NEW PRUE ROAD MDP

MASTER DEVELOPMENT PLAN

Re: New Prue Road **MDP # 022-06**

The City Staff Development Review Committee has reviewed the New Prue Road Master Development Plan **M.D.P. # 022-06**. Please find enclosed a signed copy for your files. Your plan was accepted however please note the following:

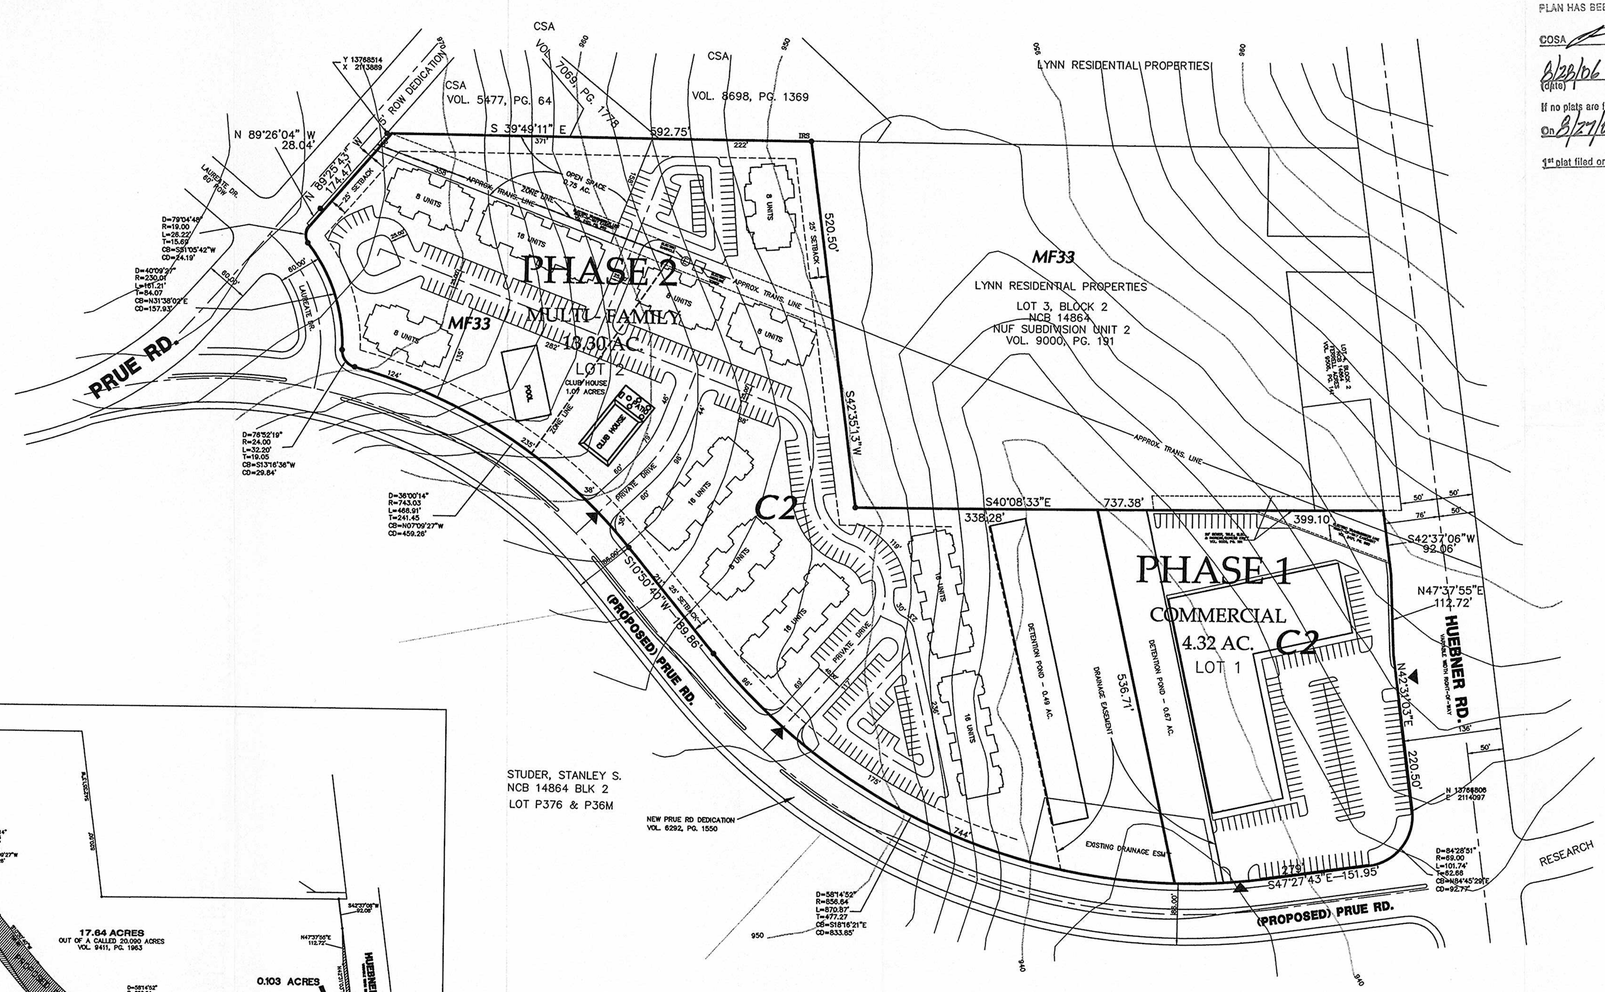
- In consideration of public safety and convenience, excessive grades by reason of topography should be avoided in street layouts and arrangements.

- Any access and R.O.W. issues along state facilities will need to be resolved with the **Texas Department of Transportation (TXDOT).** For information about these requirements you can contact TXDOT at 615-5814.

- **Parks** recommends approval with the following conditions:

The parkland provided is dedicated to the owners of the proposed multi-family units.

- The note stating the Home Owner's Association responsibilities be removed if there will be no HOA for this proposed development.

- **Trees** approves with the following conditions:

- 2003 Tree Preservation ordinance standards per UDC 35-523 – a Master Tree Permit has been approved for this development – A/P 1052162.

- Streetscape standards apply as per UDC Section 35-512 (we recommend preservation of existing trees where available and possible)

- It will be expected that you will plat all of the property depicted in your Master Development Plan (M.D.P.) to include floodplains, drainage areas and open space.
